## TOLEDO - LUCAS COUNTY PLAN COMMISSIONS

REF: Z-8004-24

SUBJECT: Review and Adoption of Institutional Campus Master Plan at 2225 Nebraska Avenue

Request	-	Review and Adoption of Institutional Campus Master Plan
Location	-	2225 Nebraska Avenue
Applicant /Owner	-	Toledo Public Schools 1609 Summit Street Toledo, OH 43604
Design Professional	-	Kevin Young, AIA Munger Munger & Associates Architects 225 N. Michigan Street Toledo, OH 43604

NEIGHBORHOOD PROTECTION PLAN  
 SCALE: 1" = 80'-0"

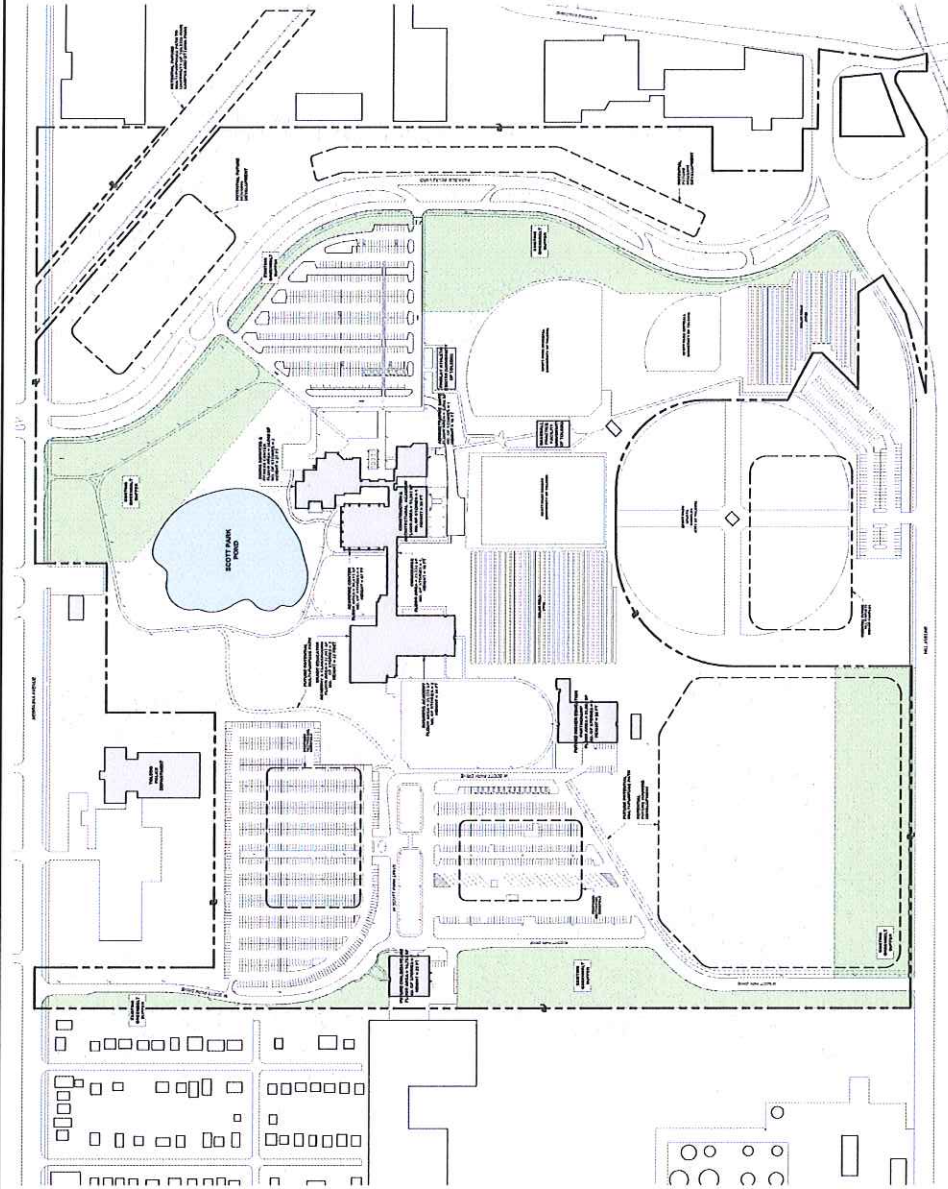
**Staff Comment:** Established landscape buffers exist on the site; however, there is a lack of appropriate landscaping in the buffer along a portion of Scott Park Drive on the northwest part of the site adjacent to existing single-family homes. An appropriate landscape buffer shall be installed as a condition of approval. In addition, a solid evergreen hedge shall be installed along the east parking lot fronting on Parkside Avenue and along west parking along Scott Park Drive to shield the abutting roadway and residences from vehicle headlights as a condition of approval.

31. A landscape buffer shall be installed along West Scott Park Drive on the northwest part of the site adjacent to existing single-family homes.
32. A solid evergreen hedge shall be installed along the east parking lot fronting on Parkside Avenue to shield the abutting roadway and residences from vehicle headlights.
